Tyler Grange Ref. 16162_R02a_Arboricultural Addendum Note_21052024_WS

Mercury 62, Knowlsey 21st May 2024

Purpose

- 1.1. This note has been prepared by Tyler Grange Group Limited (TG) on behalf of Maro Developments to accompany their planning application (Ref 22/00587/FUL) which now includes for a retaining wall on the western elevation of the proposed vehicular access point off Cronton Road. The retaining wall has been included within the proposal to reduce the amount of tree loss required to facilitate construction of the proposed vehicular access point.

Figure 2: Refined proposed tree loss (as detailed in Enclosure 3).

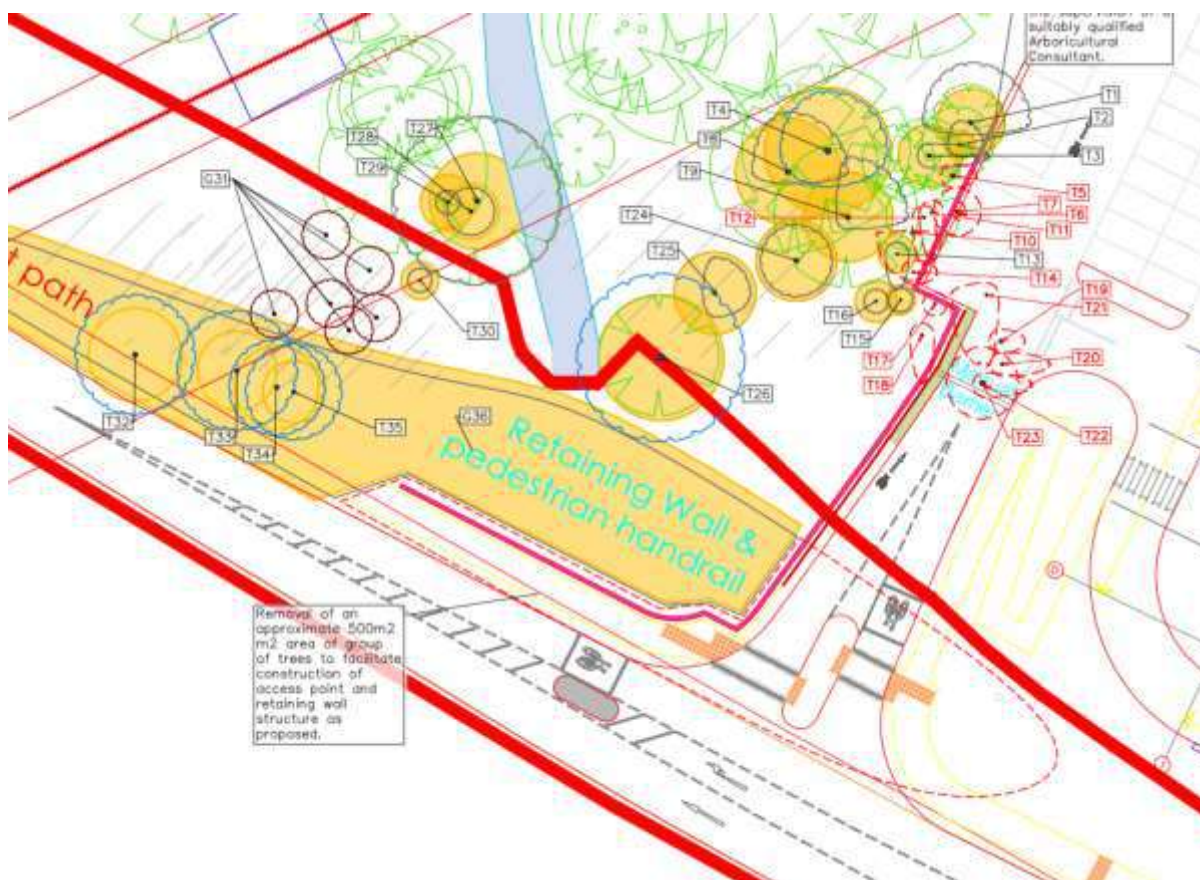
- 1.4. The proposal now includes for a retaining wall to support the edge of the elevated car park/ access road off Cronton Road into the site. An assessment has been completed and the findings are that the trees to be removed has reduced in comparison to the previous AIA (See Enclosures). The table below has been produced to provide a more detailed description of tree losses in association with the proposed retaining wall. The area proposed for the retaining wall was marked on site prior to the survey update to enable a detailed approach to determine the adjustments to tree loss.

- 1.7. The refined survey data has enabled a more detailed approach to the proposed tree retention and removal. 14no. individual trees, in addition to a 500m² strip of trees are now proposed for removal. The previous survey and report did not identify nor detail the number of trees to be removed in this area. The refined survey data identified that a large portion of the previous proposed tree removals consisted of scrubby selfseeded trees, measuring less than 75mm diameter at breast height, which within the context of BS5837 do not meet the requirements to be considered a material constraint to development. As such, the survey refinements have established that there has been an overall reduction in the amount of tree removal required to facilitate construction of the retaining wall structure and access road as proposed (See Figure 2 below).

Drawing title
Tree Retention and Removal Plan

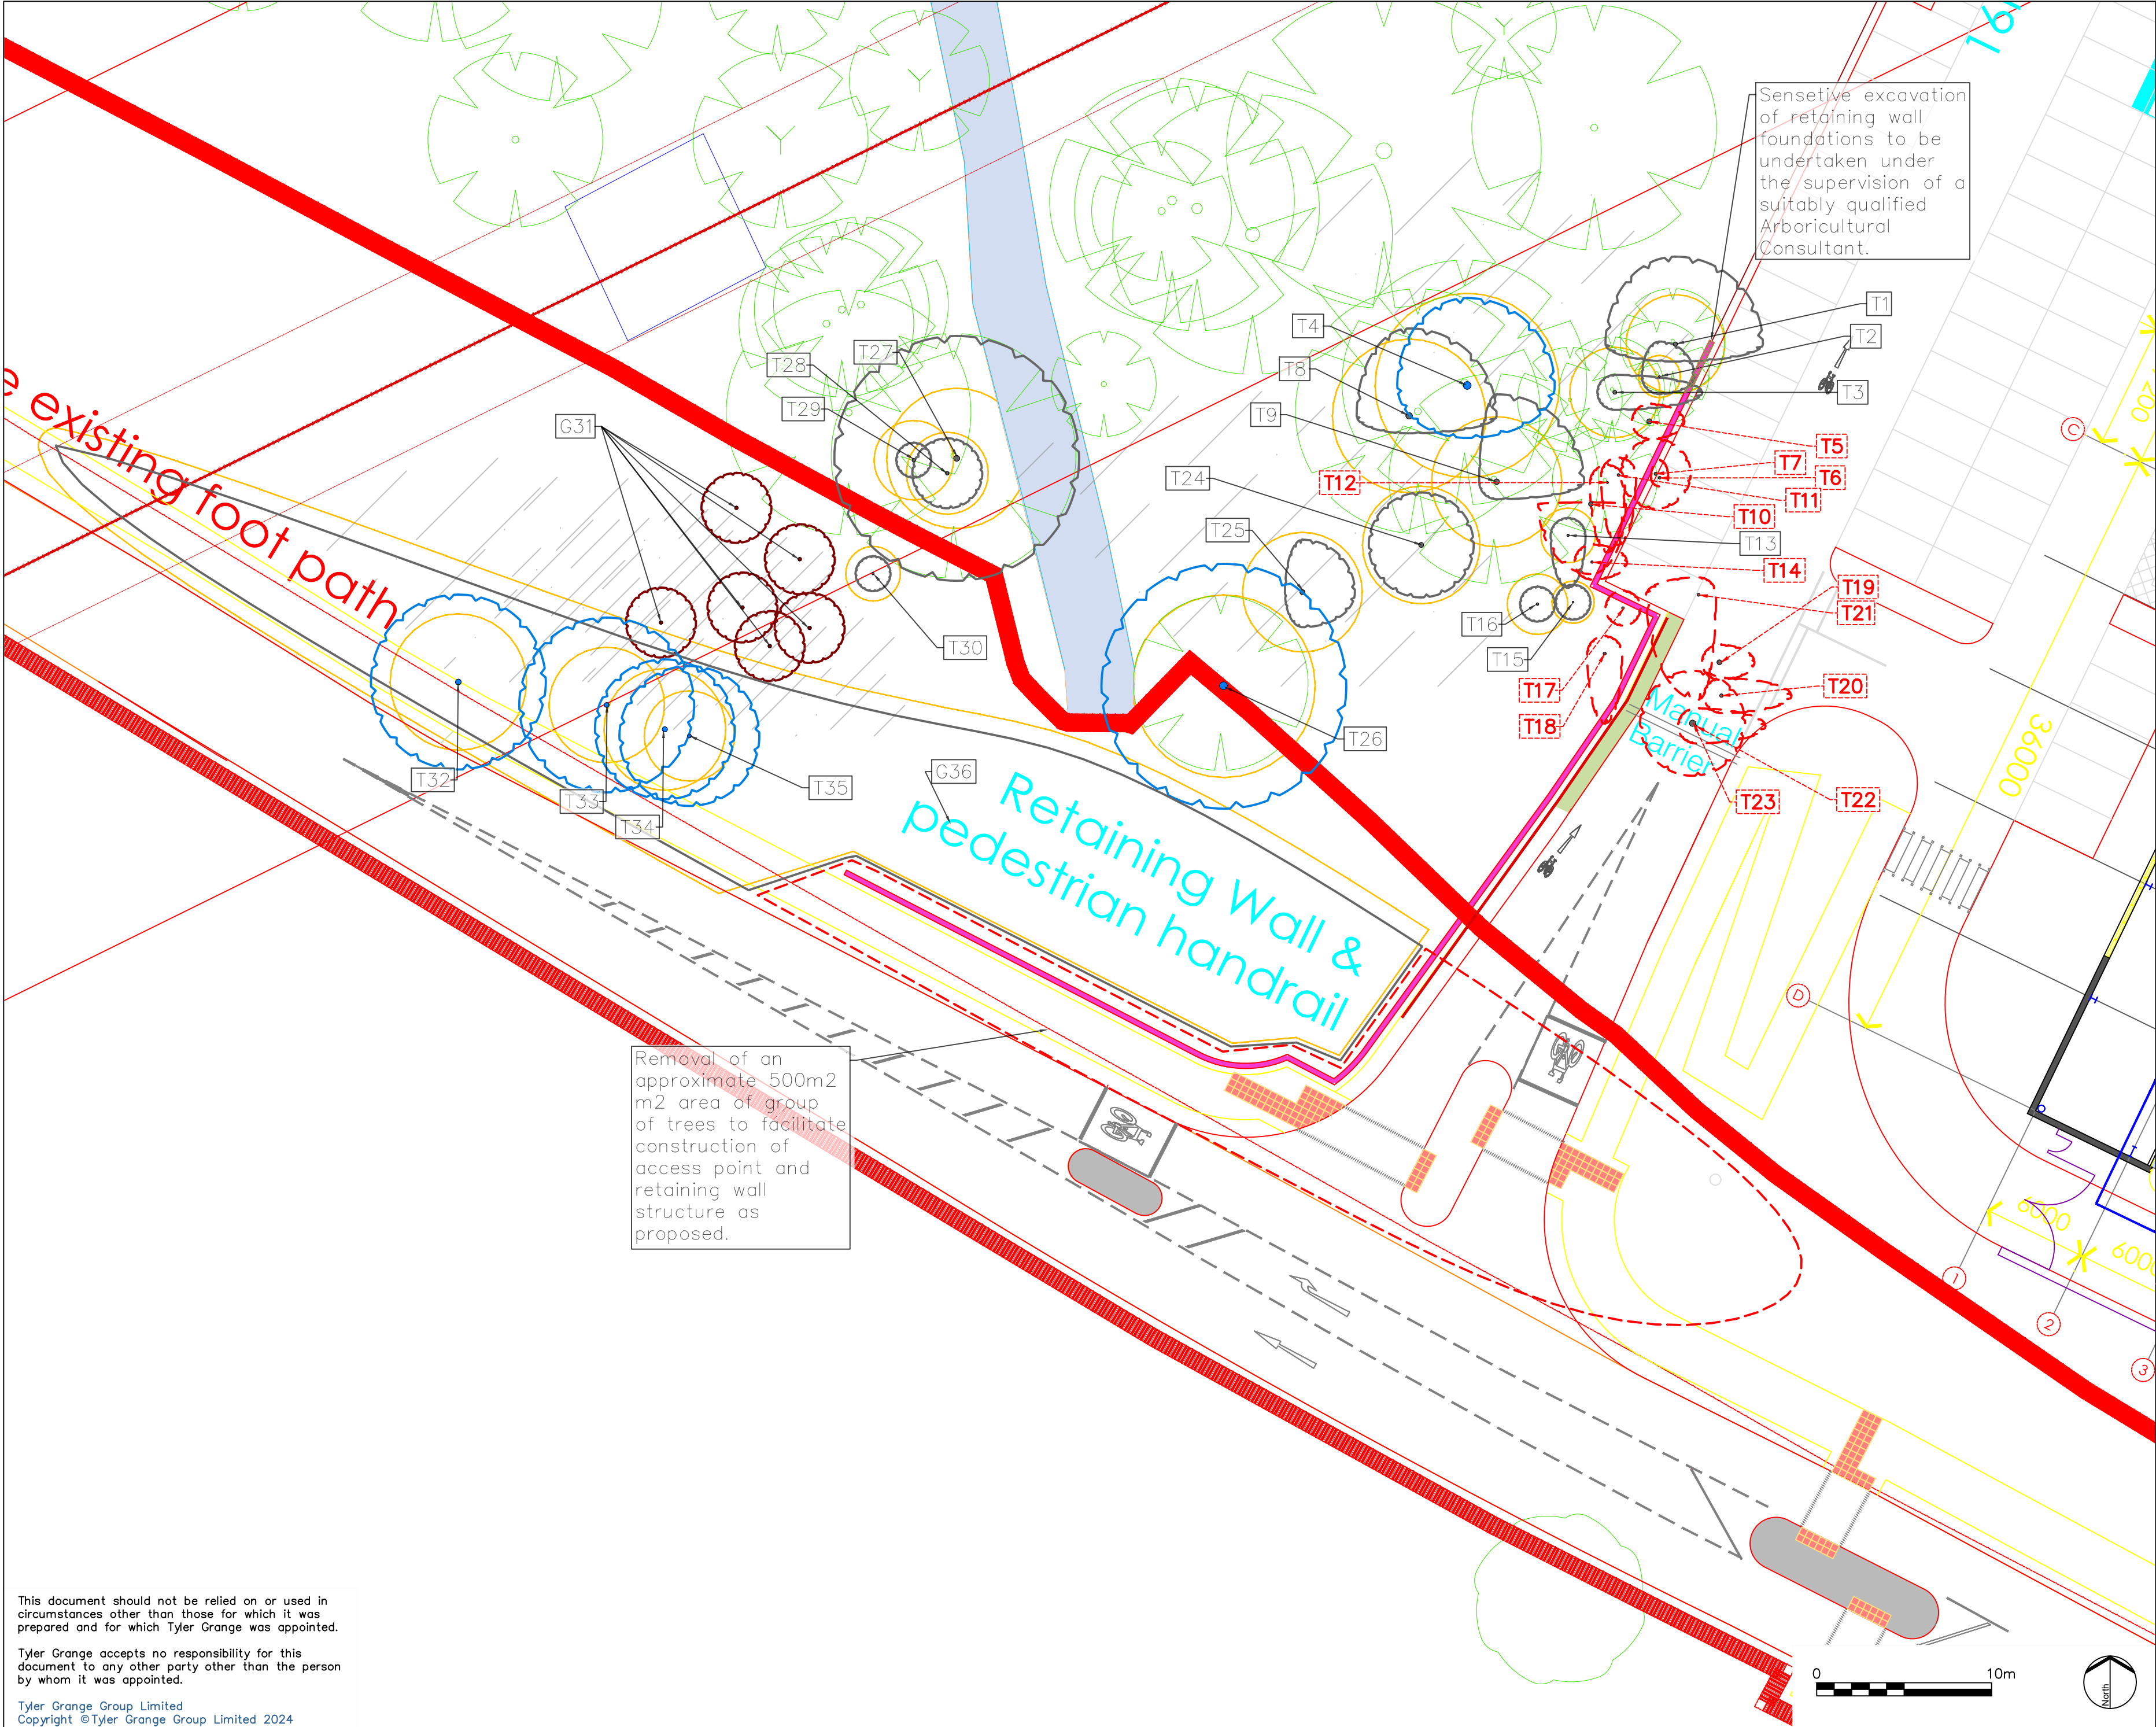
A	Tree Removal Amendments	15.05.2024
Rev	Description	Date
